**Document**
20240027-AR-DA002

**Project**
16-20 Old Castle Hill Road, Castle Hill

# SDRP HDA Response Report

## 16-20 Old Castle Hill Road
## Castle Hill

# 3.4 Architectural Planning & Refinement
## Affordable Housing

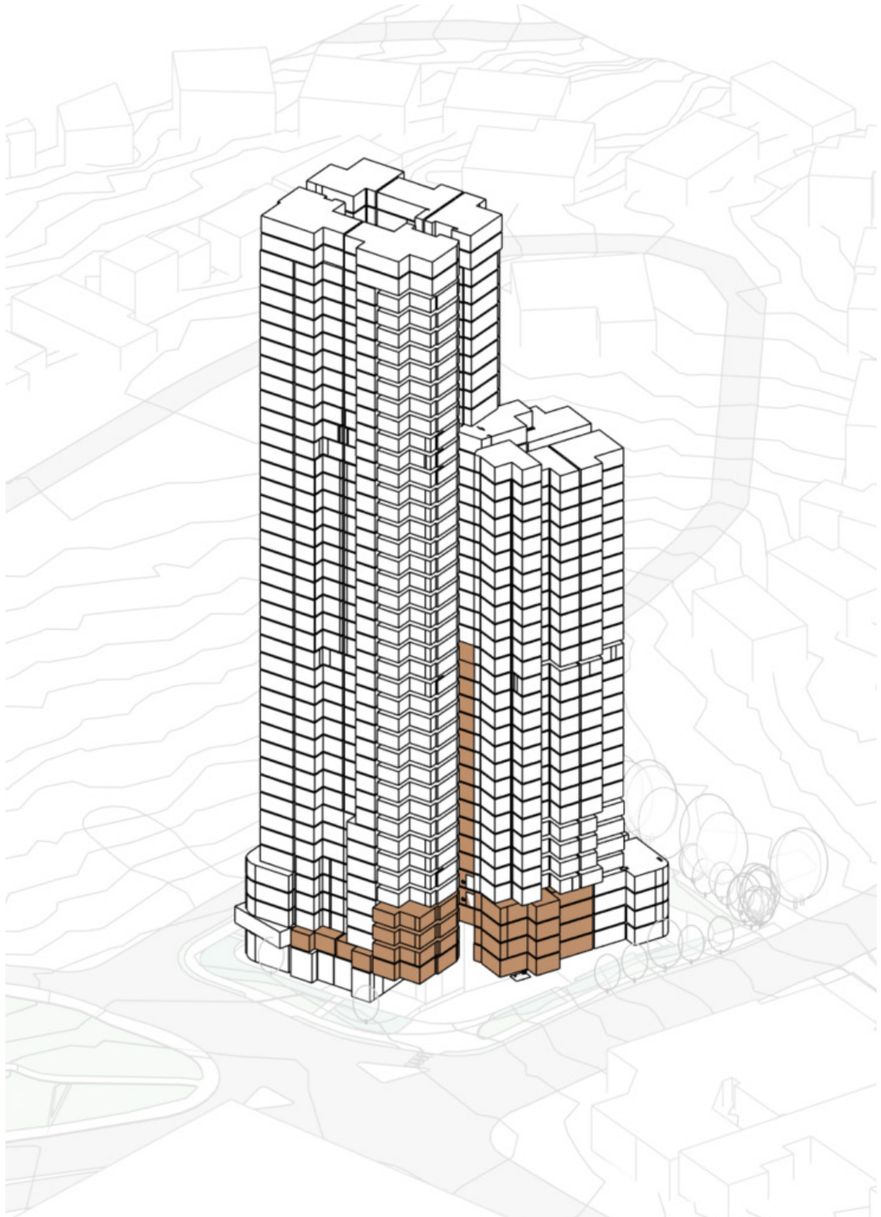
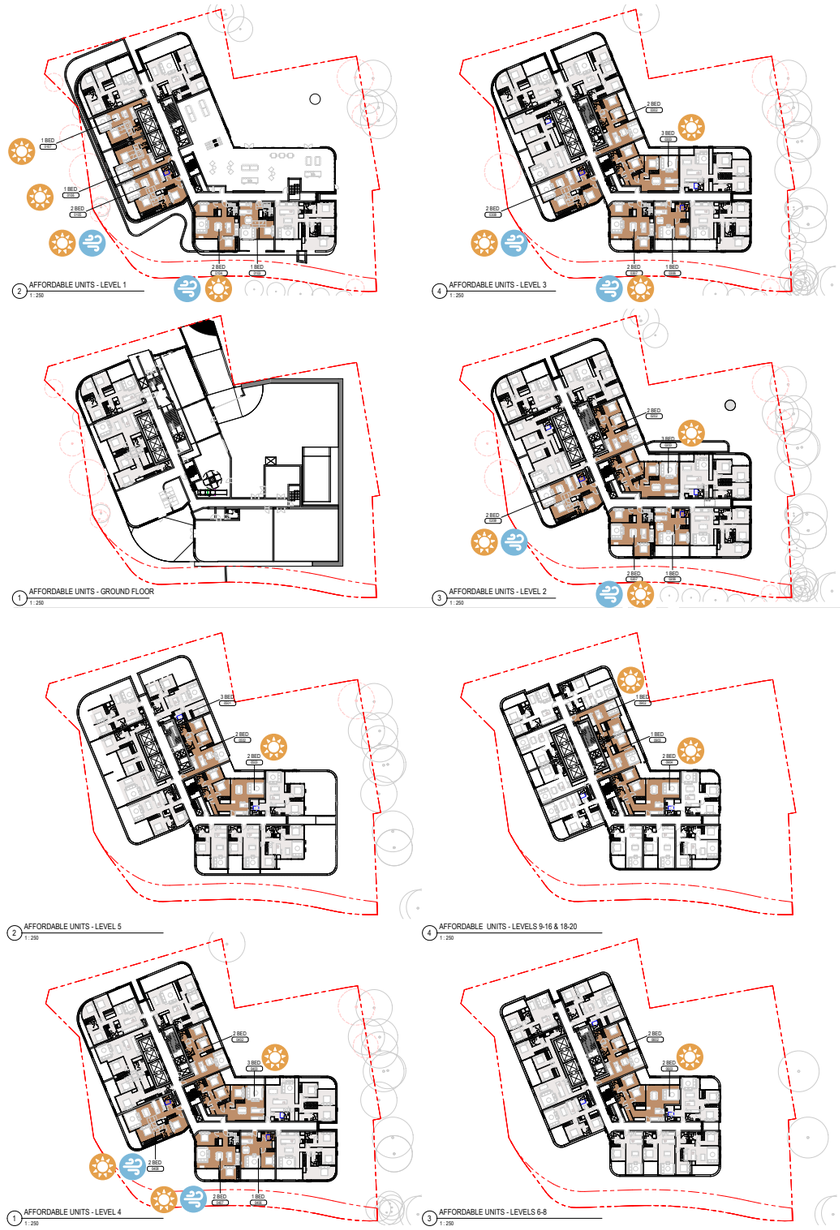
- **Item 23.** Clarify the location and distribution of affordable housing and demonstrate equitable access to amenity. Provide comparative analysis of amenity for affordable housing against market housing, including solar access, cross ventilation and access to communal space.

Affordable housing **comprises 15% of the total GFA** and is distributed throughout the building within **1B and 2B apartment types** on both sides of the tower. The affordable housing is vertically integrated within the broader residential mix, ensuring equitable access to building amenities and communal spaces. Apartment selection **includes north-facing opportunities and desirable outlooks**, including city views. Overall distribution ensures affordable housing opportunities **receives solar access** and **access to communal open space** consistent with market housing (see diagram). The final allocation and location of affordable housing apartments will be confirmed in consultation with the operator and client.

# 4.1 Facades & Materiality
## Primary Framing

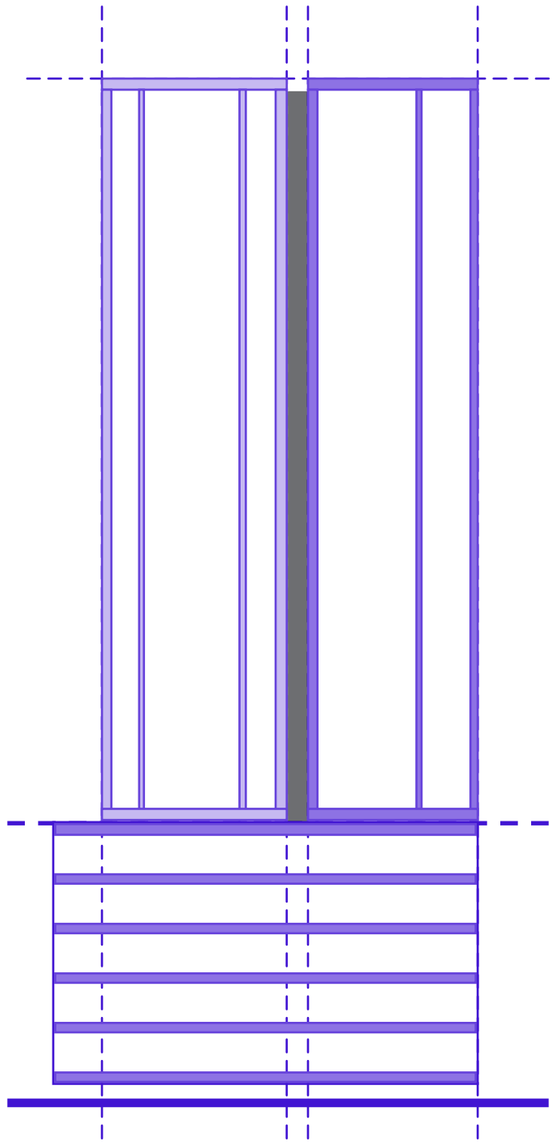
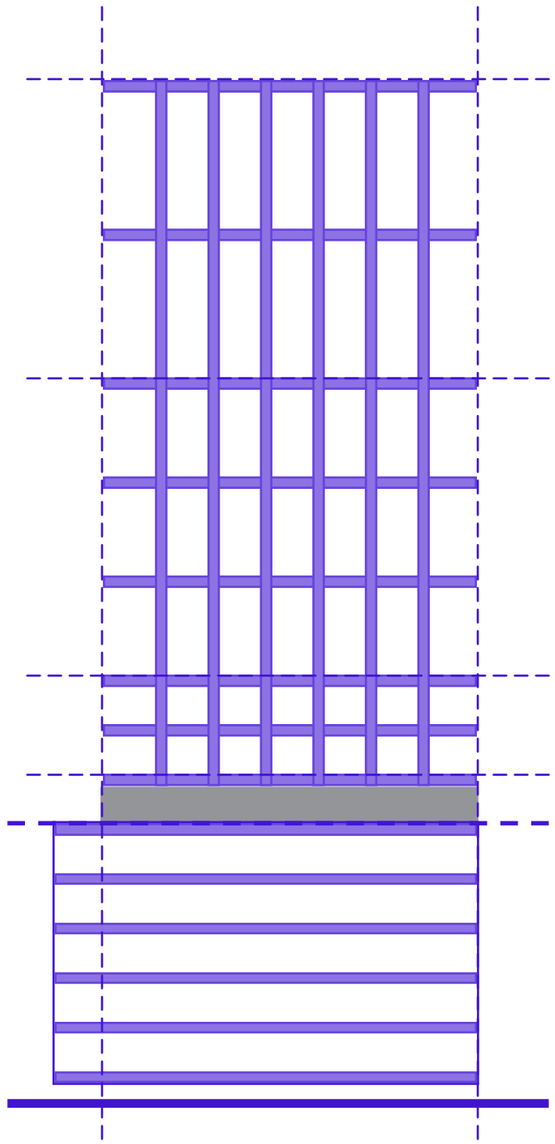
- **Item 22.** Refine the architectural expression of the tower.
- **Item 22a.** Respond to the substantial extent of facade through further articulation and a clearer and more coherent design language, noting the current infill elements read as fragmented. Consider implementing a ‘top, middle, bottom’ datum.
- **Item 22b.** Develop the facade strategy to respond to specific orientations. Provide effective external solar shading to northern, western and eastern-facing apartments to reduce summer heat load and improve environmental performance.
- **Item 22c.** Revise the colour palette considering the previous scheme which presented warmer tones and more contrast between towers.
- **Item 22d.** Ensure the architectural expression contributes to the identity of the tower and responds to its prominent location in a changing skyline.

The architectural expression of the tower has been refined to establish a clearer and more coherent design language. The primary façade framing has evolved from continuous vertical elements to a more articulated grid expression organised around distinct top, middle and bottom datums, improving the building's overall proportion and legibility. Secondary framing has been refined from continuous horizontal banding to a layered composition incorporating recessed pocket elements, creating greater depth and visual interest and achieving architectural coherence. The infill treatment has also been redesigned from fragmented rectangular elements to a more cohesive gradient pattern, reducing perceived bulk and providing a more unified architectural expression across the tower. The façade strategy has additionally been refined to respond to solar orientation, incorporating integrated shading elements and recessed façade treatments to northern, eastern and western elevations to reduce solar heat gain, improve occupant comfort and enhance the environmental performance of the building.
